FIELD SERVICE BULLETIN

SERVICE DEPARTMENT
CONSOLIDATED VULTEE AIRCRAFT CORPORATION
San Diego, California, U.S.A.

October 15, 1944

Figure 2. New Routing of Static Air Pressure Tube

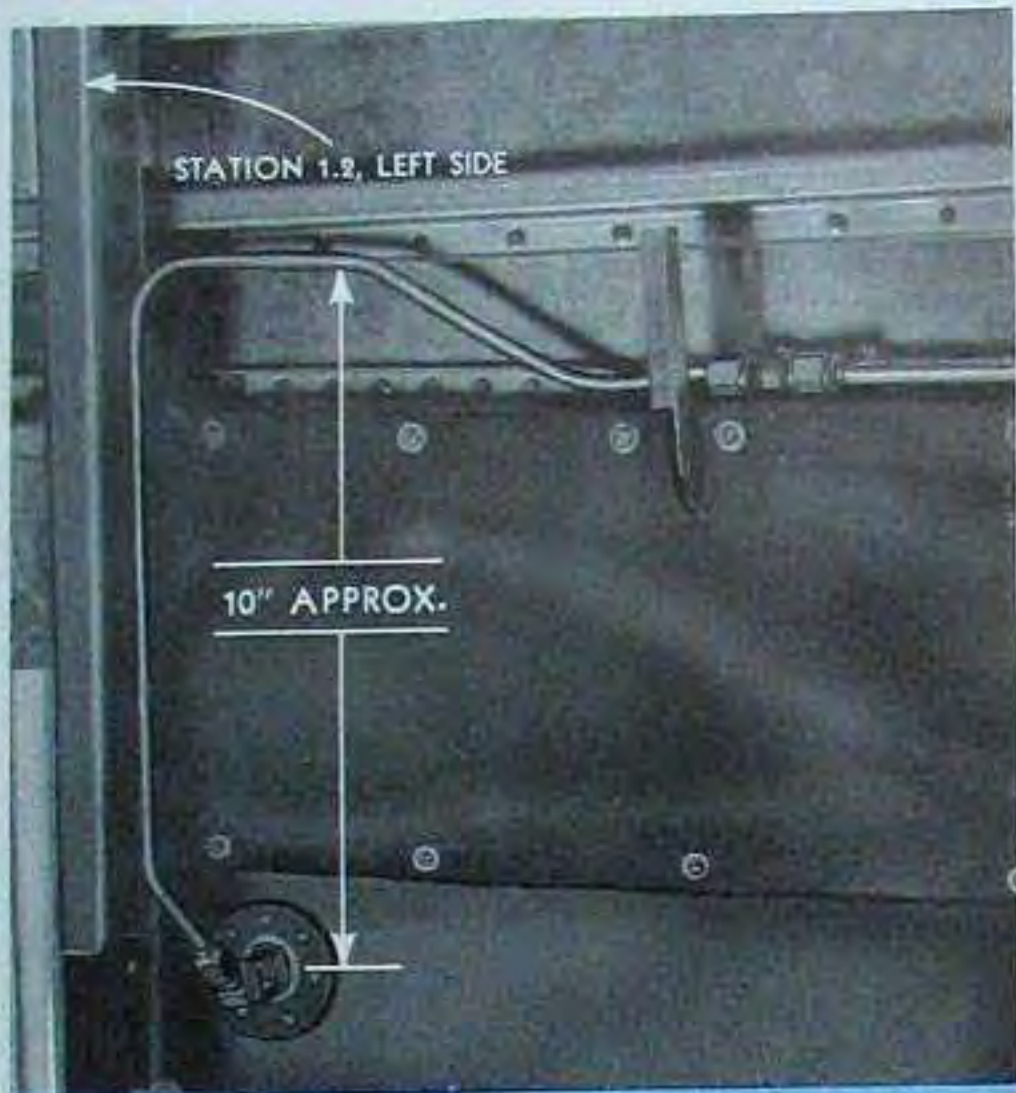
THE tubes leading from the static air pressure openings on B-24 type airplanes have been rerouted to prevent moisture from entering the static lines thereby causing erroneous indications of the altimeter, air-speed indicator, and rate-of-climb indicator.

The revised tubes (refer to 32F36100) have been provided with a 10" rise, as illustrated in figure 2. This rise in the tubes is sufficient to keep water out of the static lines; however, the static and pressure lines should be drained periodically to remove any condensed moisture. (Refer to Field Service Bulletin, Volume 2, No. 14, page 200).

Figure 3. Cast-In Vane Carburetor Air Duct, Rear View

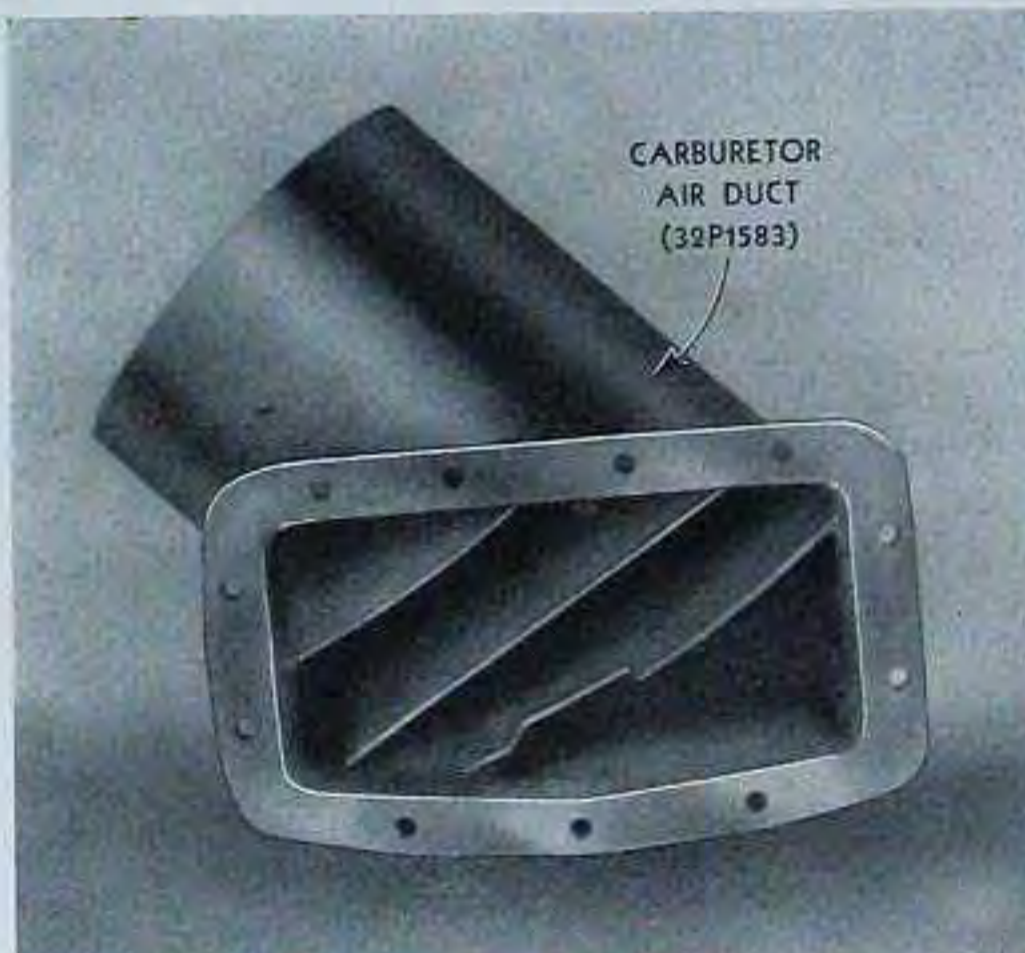
A CAST aluminum carburetor air duct (32P1583), incorporating cast-in vanes, has replaced the former riveted vane ducts installed on B-24 type airplanes (figure 3). Cast aluminum construction eliminates the use of rivets and is superior in strength to the riveted vanes.

The cast-in vanes are capable of withstanding higher vibrational loads and will eliminate the possibility of broken parts and rivets dropping into the blower section of the engine with consequent damage to aircraft and equipment.

Figure 4. Servo Motor Heating Pad Installed

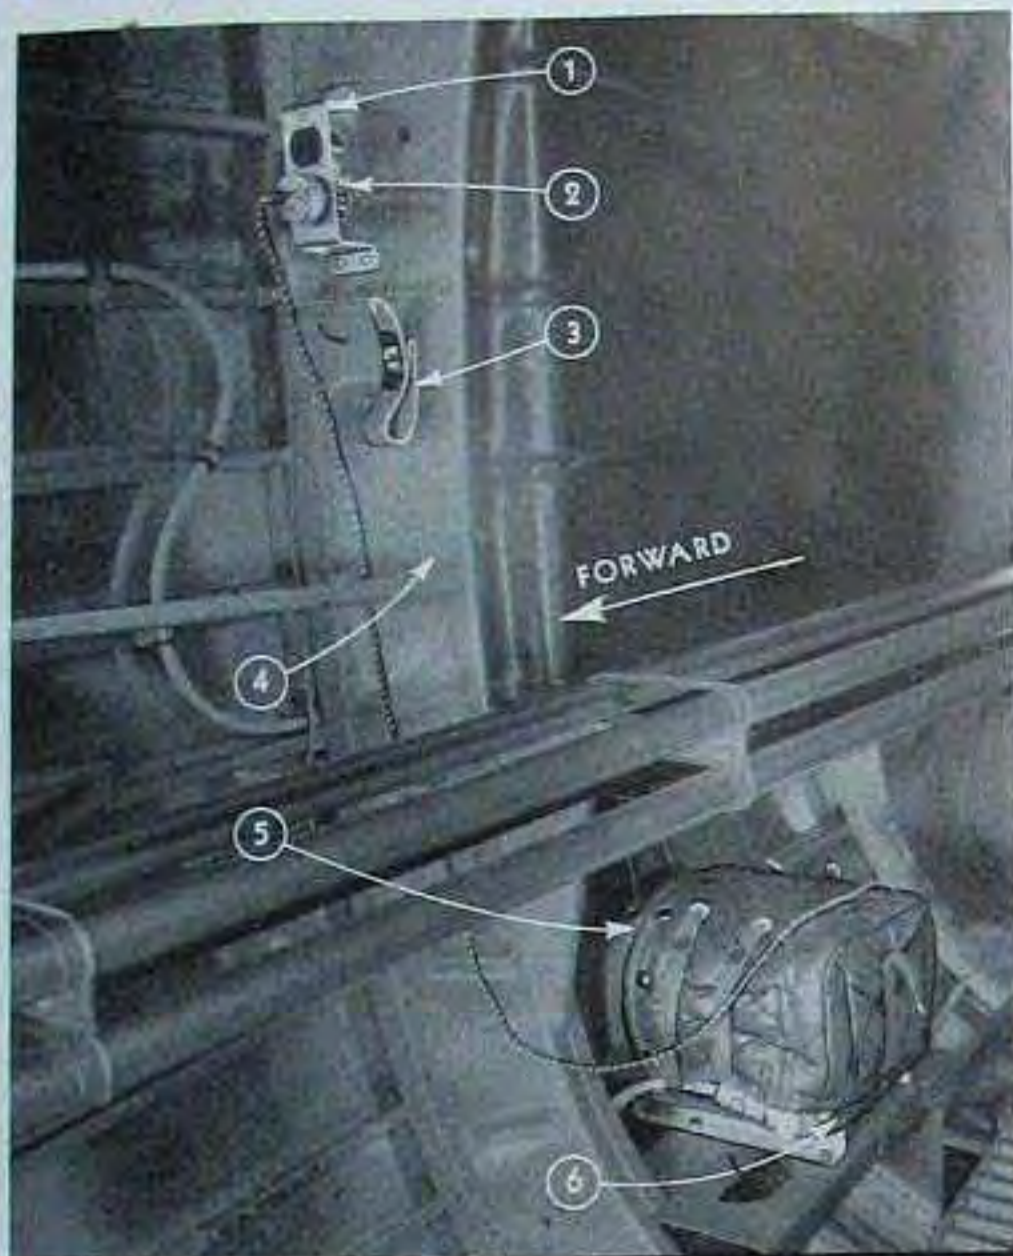
A HEATING pad unit has been installed on the elevator servo motor of B-24 type airplanes to prevent malfunctioning of the unit during operation in freezing temperatures. An electric receptacle has been

The heating pad installation (figure 4) consists of a cover (5), base pad (6), and six mounting spacers. An electric cord is supplied with the heating pad. An electric receptacle (2) has been installed on the right forward face of the bulkhead at station 8.0. An electric harness has been installed to connect the receptacle with the tail turret power switch box where a 2 ampere fuse is installed for the heating circuit. A strap (3), installed below the electric receptacle, provides safe and convenient stowage for the electric cord.

Figure 5. Typical Installation of Improved Box Assembly

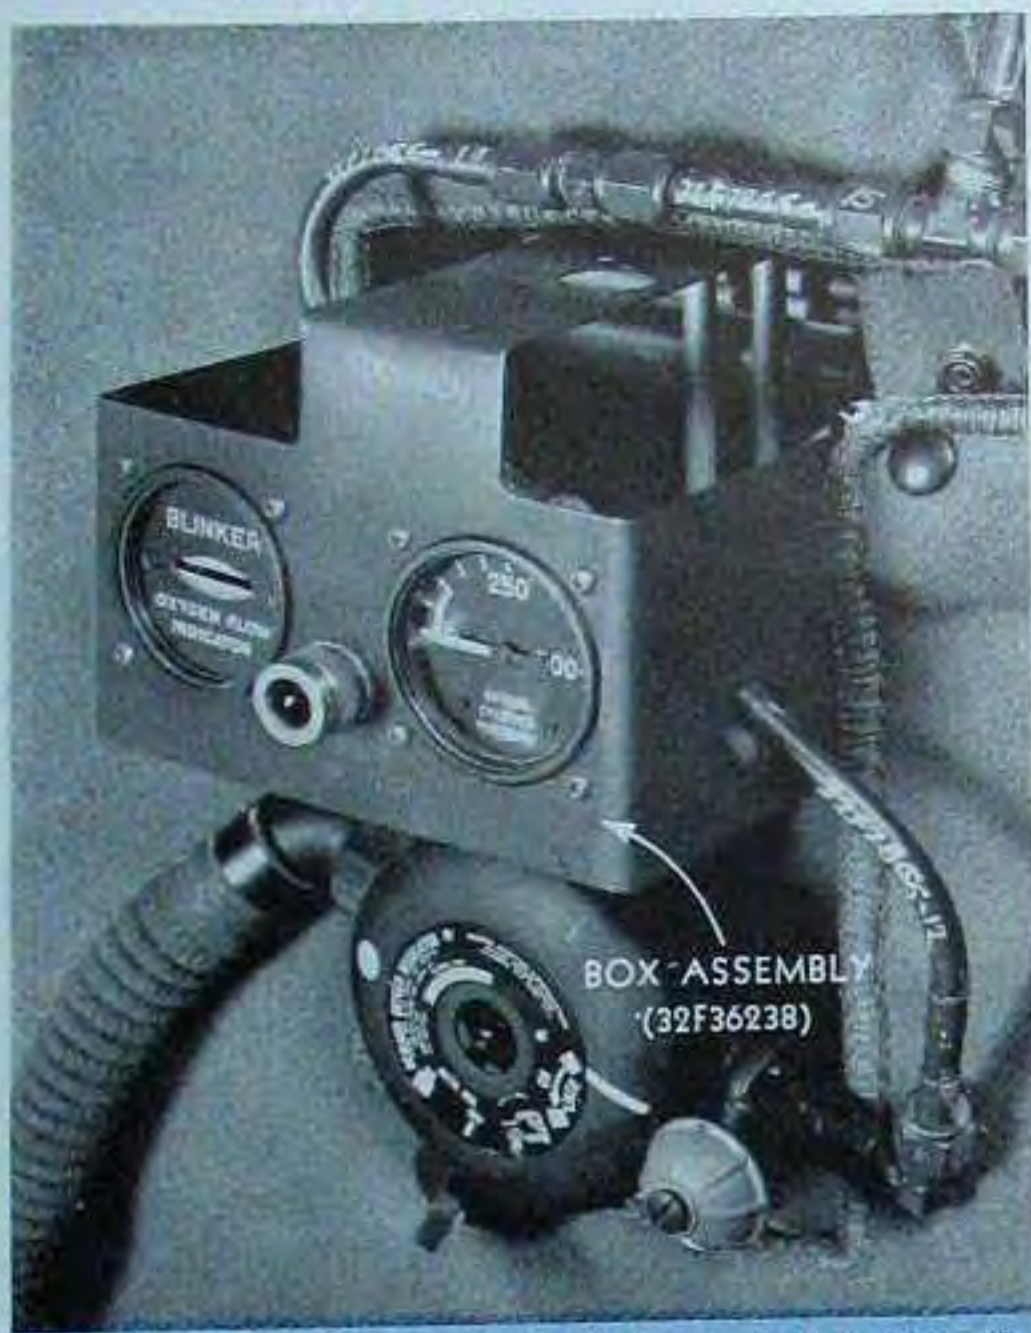
AN IMPROVED box assembly for the demand oxygen system panels has been installed on B-24 type airplanes.

The new box assembly (32F36238), installed under 32F36239, is made of alclad sheet and has been designed with maximum allowable cutouts (figure 5). These cutouts provide greater accessibility for the removal and inspection of instruments and fittings without the necessity of dismantling the panels.

Figure 6. Auxiliary Power Unit Grounded to Base

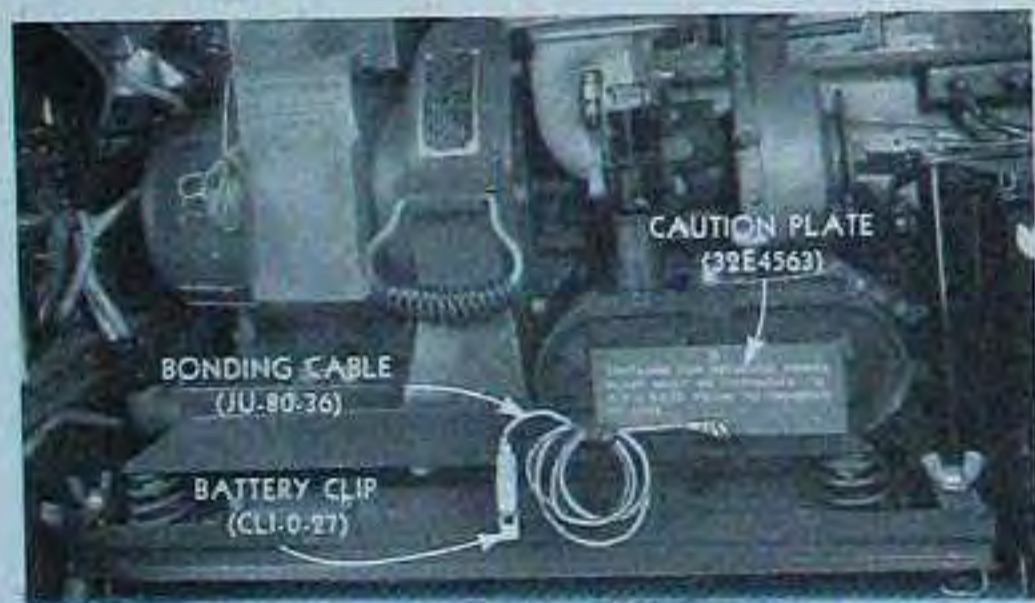
A BONDING CABLE (CVAC Part No. JU-80-36) and a battery clip (CVAC Part No. CLI-0-27) have been installed on the auxiliary power unit of B-24 type airplanes as a precautionary measure to prevent possible fire which could be caused by an accumulation of static electricity in the power unit.

The unit, located on the left side of the fuselage forward of the bulkhead at station 4.0, is grounded by attaching the battery clip to the base of the unit prior to refilling the fuel tank (figure 6).

Figure 7.

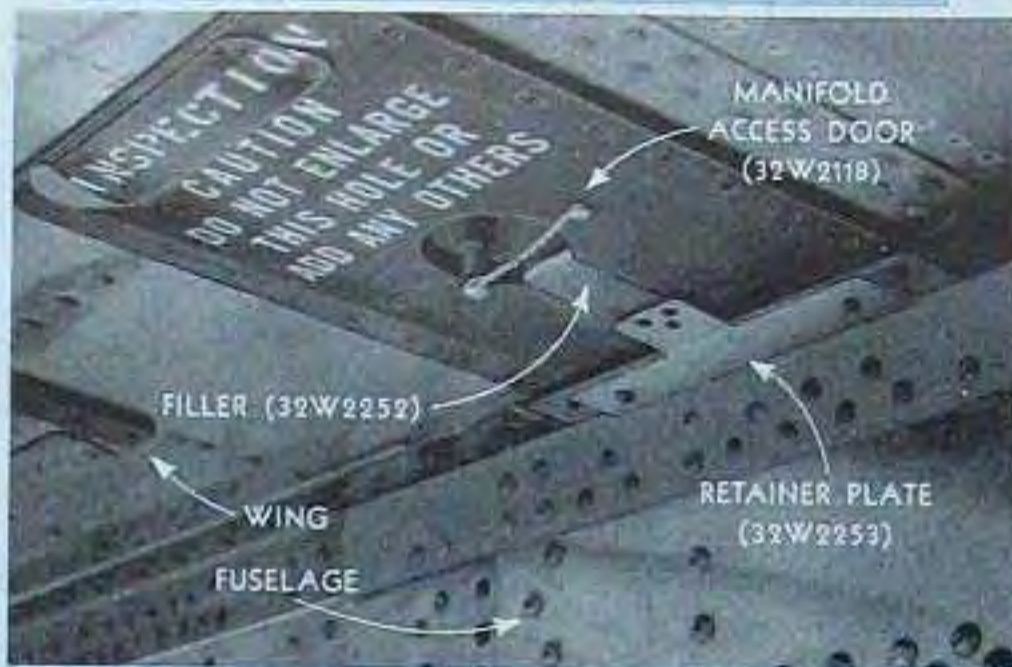
PREMATURE deterioration of the No. 2 main fuel cell manifolds in the wing has necessitated covering the No. 2 cell manifold drain openings in the manifold access doors at wing station 2, left and right.

Installation of a filler block (32W2252) in the opening (figure 7), prevents air from circulating around the fuel cell manifold, thus retarding deterioration of the synthetic rubber manifold. A retainer plate (32W2253) has been installed on the outside of the access door to hold the filler block in position.

Figure 8. Mixture Control Quadrant Mark at Auto Lean Position

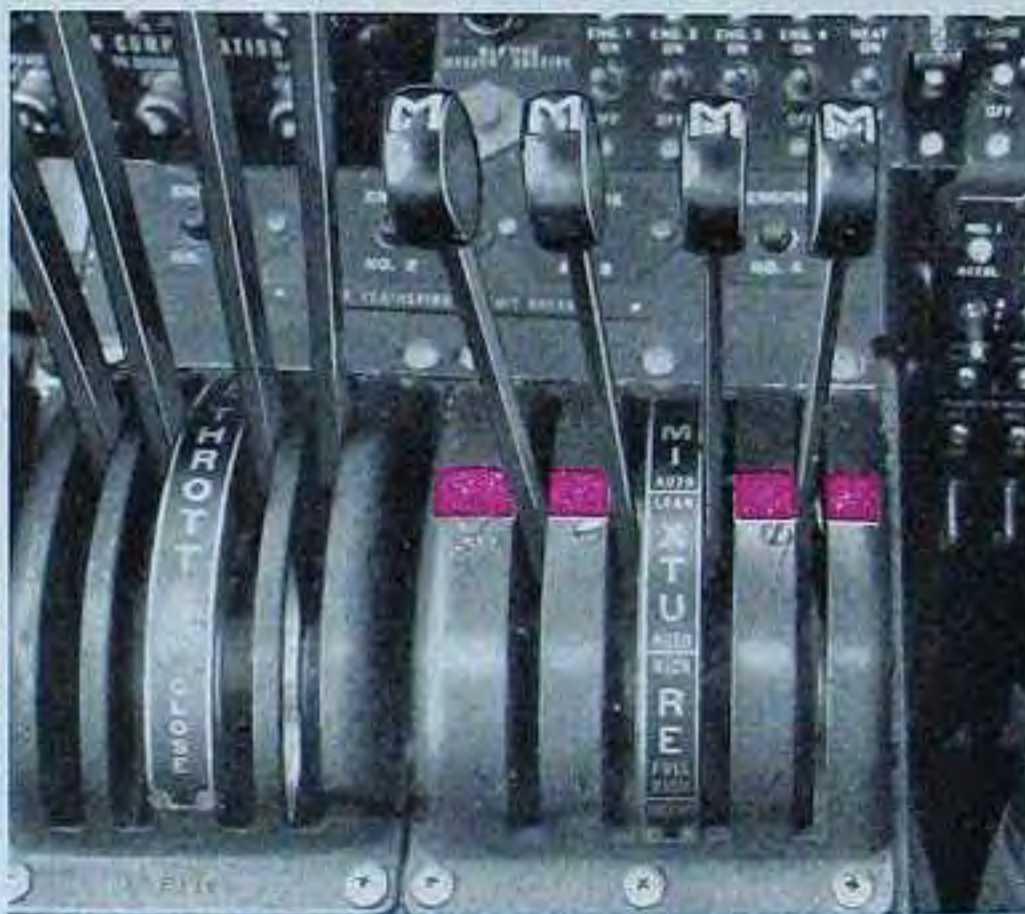
The Technical Order further directs the painting of a red band across the carburetor mixture control quadrant, centered at the auto lean position, after the controls have been re-rigged. This band, the exact width of the control levers (figure 8), serves to notify the pilot of properly rigged carburetor mixture controls.

THE mixture control linkage of B-24 type airplanes will be inspected to comply with Technical Order No. 01-5E-48. In the event the mixture control selectors on the carburetors do not coincide with the mixture control levers on the pilot's pedestal, the linkage should be disassembled and re-rigged.

Improper rigging of the carburetor mixture controls can cause malfunction of the engine due to the lean metering of fuel. The mixture control selectors on the carburetors, when in the auto lean position on all four engines, must coincide with the auto lean position of the mixture control levers on the pilot's pedestal.
